THE MARYLAND-NATIONAL CAPITAL PARK AND PLANNING COMMISSION

MEMORANDUM

REVIEW TYPE: Site Plan Review
APPLYING FOR: Approval of Concept Master Plan Amendment for Johns Hopkins University Campus on 35.57 acres
PROJECT NAME: Johns Hopkins University – Concept Master Plan
CASE #: 8- *86065A*
REVIEW BASIS: Sec. 59-D-3, M. C. Zoning Ordinance

STAFF RECOMMENDATION: Approval Concept Master Plan Amendment

MP 1.01

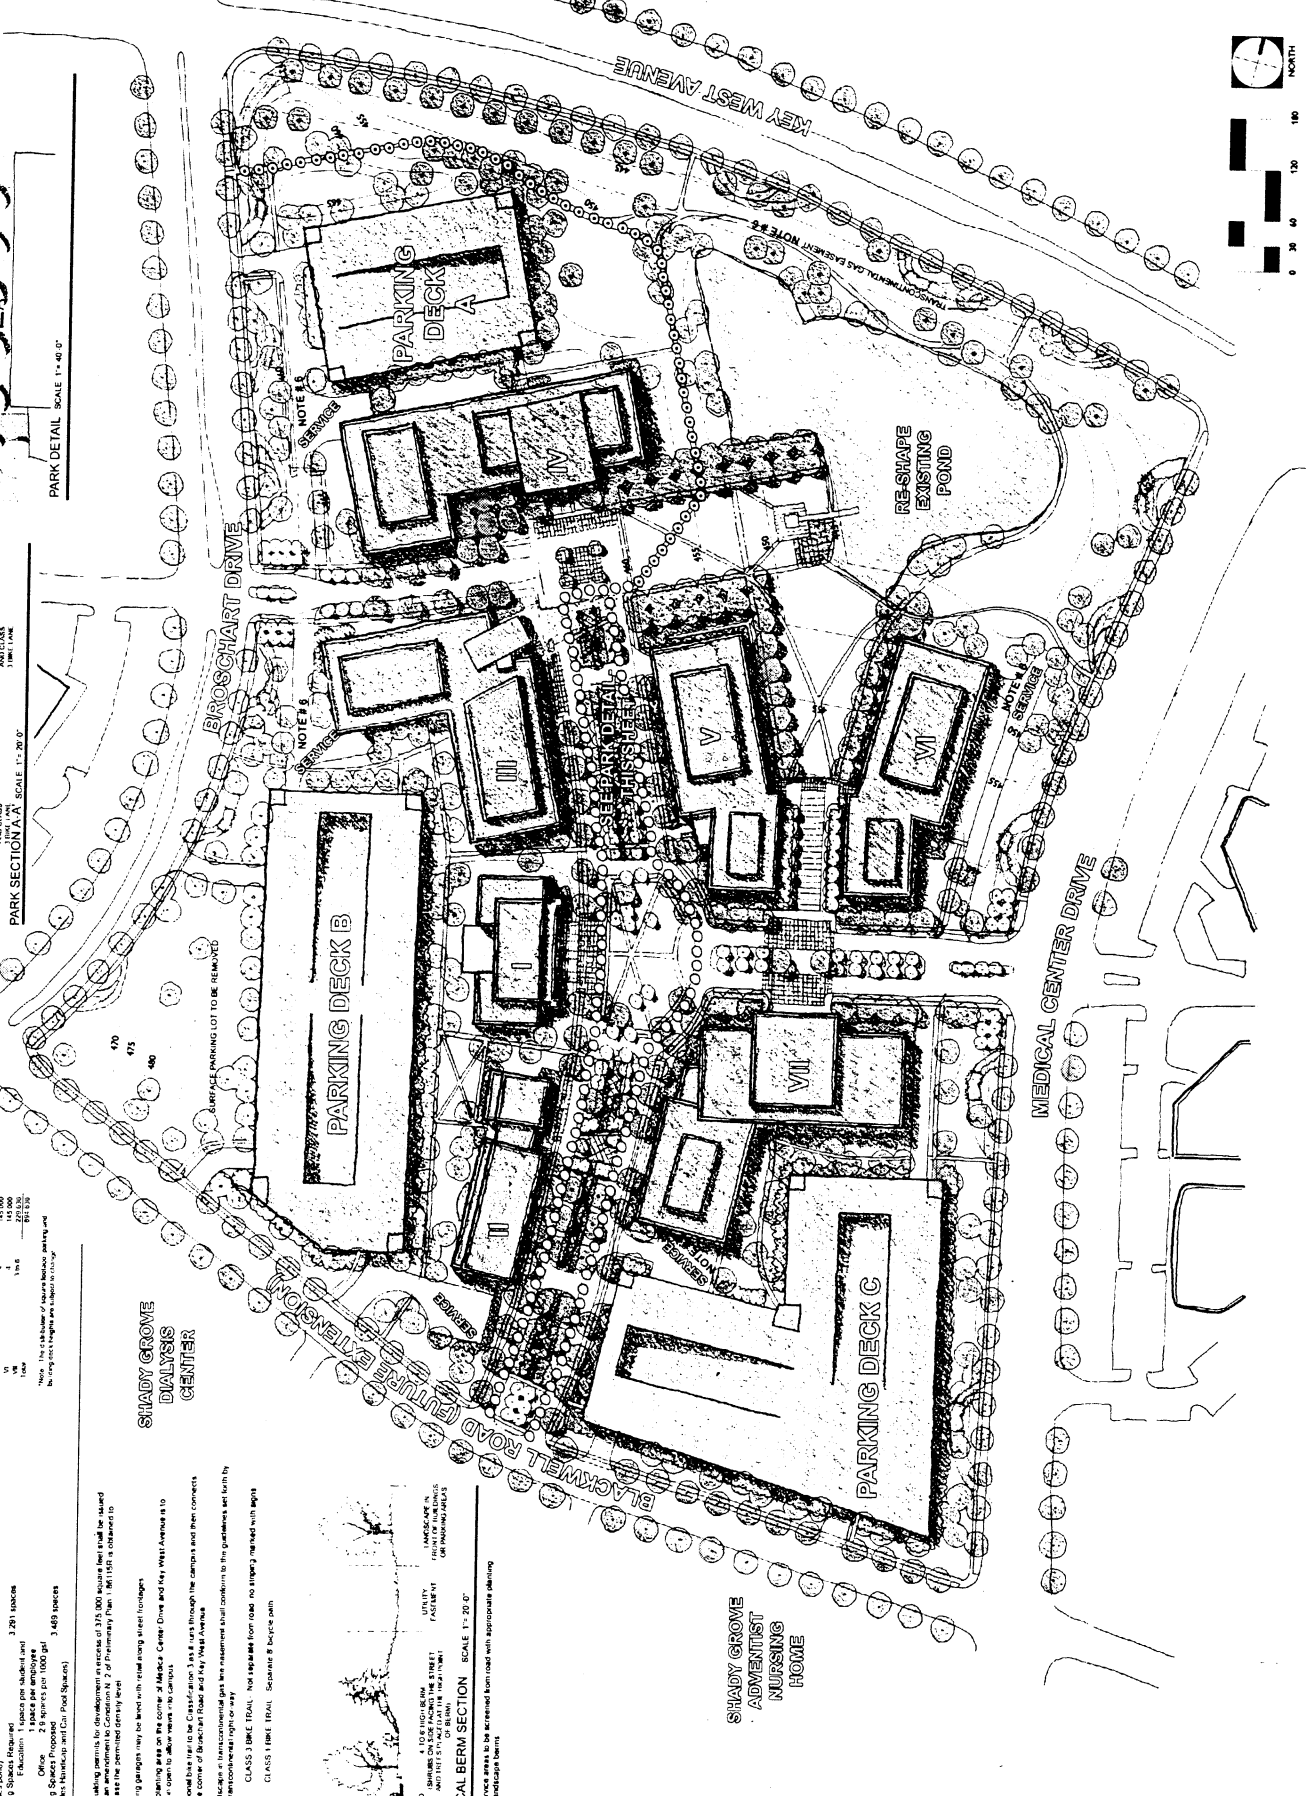
In consultation with staff, the applicant revised their original concept to include a connection of the “village street” to Broshcart Drive, thus requiring the building to be re-designed in an “L” shape. There was improvement to the building massing (less linear frontage along the “village street”), improved visibility to Key West Avenue and a great improvement to the interconnection of this campus to the adjoining streets.

Building massing: The village street is lined with the three story buildings with taller buildings placed in strategic areas that create vistas to the pond and line the main entry street from Medical Center Drive. The primary orientations of the buildings are to the internal streets – with secondary orientations to the external streets.

Pedestrian areas: The current pedestrian walk will be further developed into a “village street,” providing direct access to each building for pedestrians and vehicles. The pedestrian environment will expand from sidewalks on the outer edge of streets to include a pedestrian mall in the center median of the streets. These areas will be developed with high quality paving materials, pedestrian level lights, shade trees, detail landscaped areas, benches and other streetscape features. Crosswalks will connect pedestrians to this area safely from adjacent streets. Shown schematically here, the detailed plans for these areas will be developed with future phases, closer to the time of construction.

Pedestrian systems: Sidewalk connections will be maintained and enhanced from the adjacent streets into the “Village Street”. Additional connections were added from Medical Center Drive and Broschart Road. Connections are shown from the future Blackwell Road and all parking garages to the main pedestrian areas.

Bike Path: The Shady Grove Master Plan includes a bike path segment through the site which is currently established and will be maintained with this proposed Master Plan. The path will be a “mingled” bike path with the drive for a portion of the site and then transition to a class one path that will connect with the Key West/ Broschart Drive intersection. This intersection connects with the continuation of the bike path through the Decoverly Hall site to the north and the SGLSC open space park and Blackwell bike paths to the south.

Vehicular Circulation and Parking: Vehicular access to the site will be established from Medical Center Drive and Broschart Drive and the future Blackwell Road. These
